LODI UNIFIED SCHOOL DISTRICT

2021 Paving Projects– Phase III

ADDENDA NO. 2

March 22, 2021

SHEET TITLE
**SPRINKLER
IRRIGATION PLAN
CAMPUS AREA**

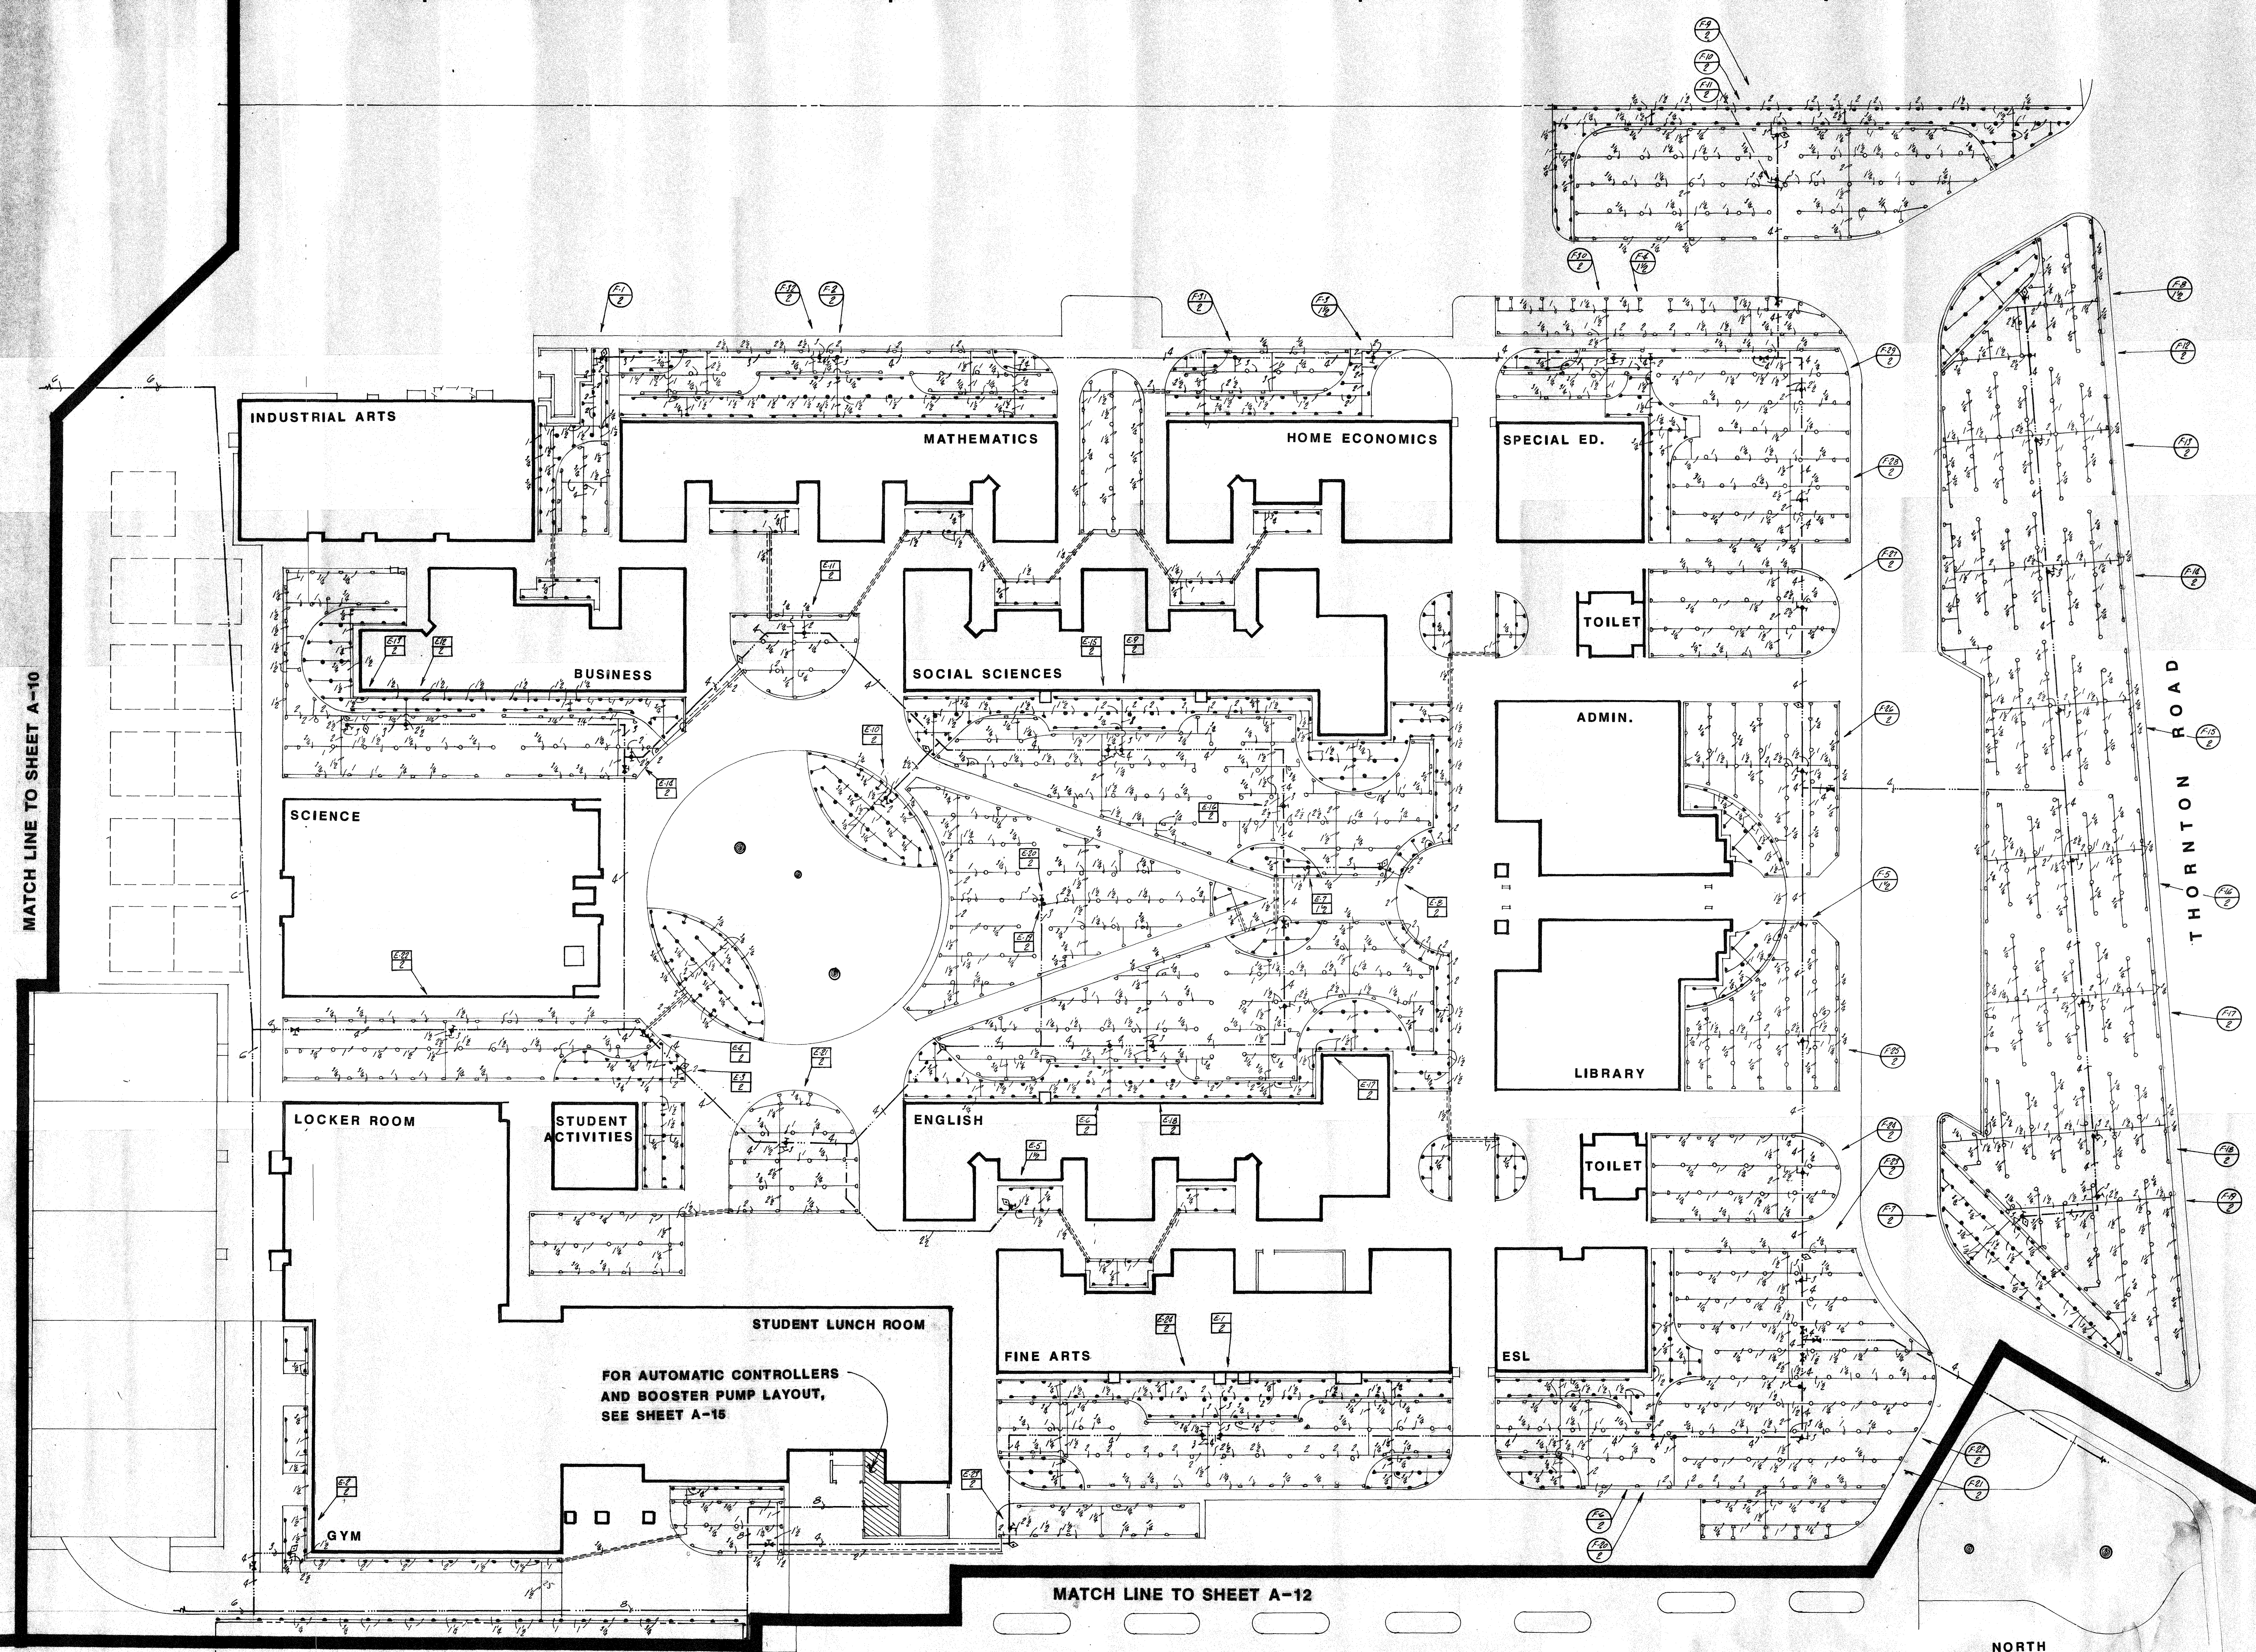
2.3 Bear Creek High School – Project #0949-8249 – DSA #02-118898. **Add** Sheet A-11 – As-Built Sprinkler Irrigation Plan Campus Area in its entirety.

2.8 **Question:** Is there an as-built drawing of the existing irrigation layout at Bear Creek HS?

Response: See attached as-built sprinkler irrigation plan sheet A-11 for Bear Creek HS.

2.11 Attached is sheet A-11, As-built Sprinkler Irrigation Plan Campus Area.
